East Suffolk Council response to the Changes consultation

December 2020

Response of East Suffolk Council

Appendix: Technical input to the changes proposals: Coastal Processes

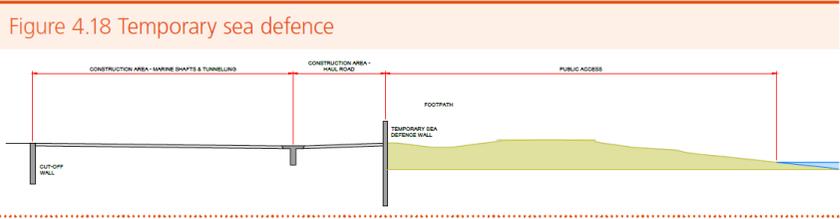
Pg. no.	Ref	Relevant text / illustration	<i>Observations and Concerns</i>	<i>Request for clarification, confirmation, or further information</i>	
		BLF options			
39	3.3.5	<p>Permanent BLF as proposed in the present DCO:</p> <p>3.3.5. The seabed in front of the permanent BLF, where the barges land, would need to be surveyed and potentially re-profiled between each delivery. This is to ensure the next barge can land safely on a reasonably smooth surface.</p>	<p>Presumably this commitment would carry through to the changes. Same survey will also help to identify before/after record of changes</p>	<p>Request for Confirmation: Please confirm that the seabed will be surveyed and re-profiled before each delivery in the case of a new BLF.</p>	
40	3.3.1 1	<p>Proposed Enhancement of the BLF:</p> <p>3.3.11. A potential change is to add submerged beams that span parallel to the beach on piled foundations, thereby creating a solid base on top of the seabed. A total of approximately 50 timber piles are likely to be needed, or fewer if steel is used. The addition, known as grillage, would cover an area of approximately 100m x 30m and would still allow the natural movement of sediment as far as reasonably practicable. The grillage would be removed at the end of the construction of Sizewell C.</p>	<p>The structure, understood to stand 1m proud of the beach, is sizeable, and one would expect it to present some impedance to sediment otherwise moving alongshore. It needs to be demonstrated that such a structure, whether in use or not, will not have an adverse impact on the local shore or interfere with longshore sediment transport.</p>	<p>Request for more information: Please provide evidence that the grillage(s) will not have a negative impact on the local shore or impede longshore sediment transport.</p>

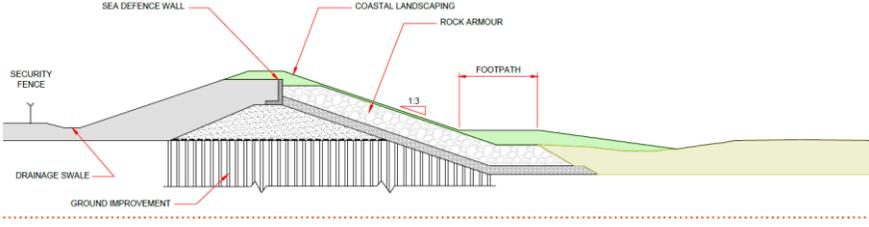
(please see also comments re p. 157 section 1.2.7).	
40	3.3.1 7	<p>3.3.17. SZC Co. is consulting on four variants to the temporary BLF design. They are most easily distinguished by: their length; whether the barge would ground on the seabed; and the rate at which they could import material. Only Option 1 and the enhanced permanent BLF would 'land' on the beach. Potential options, subject to more detailed work and this consultation, are:</p>	Saying "land" on the beach, should this not make reference to the grillage as described elsewhere?	Request for Clarification: Please clarify whether the enhanced permanent BLF would land on the beach or upon a grillage (on the beach).	
42	3.3.2 2	<p>Option 2: Temporary BLF, short pier - low capacity</p> <p>3.3.22. Option 2, as illustrated in Figure 3.4, is essentially the same design as the enhanced permanent BLF and Option 1, but with a pier that is approximately 30m longer at around 150m. The additional length means that the seabed at the end of the pier is around -3mOD, compared with around -2mOD for Option 1. This increased depth allows barges to unload without becoming grounded and makes them less sensitive to tide conditions. The seaward end of the pier may terminate in a T-shape to allow barges to ground parallel to the beach, increasing the rate at which they can be unloaded.</p>	Would the insensitivity to tidal conditions (not grounding) possibly render the facility more sensitive to wave conditions (no breakwater)?	Request for Clarification: As noted in column to left.

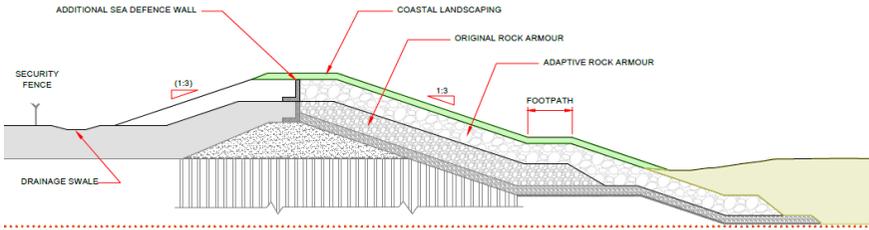
44	3.3.2 5	<p>Operation</p> <p>3.3.35. The navigation routes may require a turning circle for the barges where they adjoin the temporary BLF, with associated dredging on parts of the seabed within that footprint that rise above -3mOD. It is assumed at this stage that the same type of flat-top barges would be used</p>	<p>We are concerned about the unstated quantity of dredging to form the turning circles as any lowering of the seabed may result in higher wave conditions at the shore</p>	<p>Request for Further Information: Further quantification is sought on the depth, area and quantum of dredging require for the turning circle(s).</p>	
51		<p>Coastal Geomorphology and Hydrodynamics [With reference to the ES Volume 2 Chapter 20 (Doc Ref. 6.3)]</p>	<p>Destabilisation of the sand bar could have an adverse impact on the coastal processes at the shore.</p>	<p>Request for Further Information: Please advise on impacts of dredging at the shore and in</p>
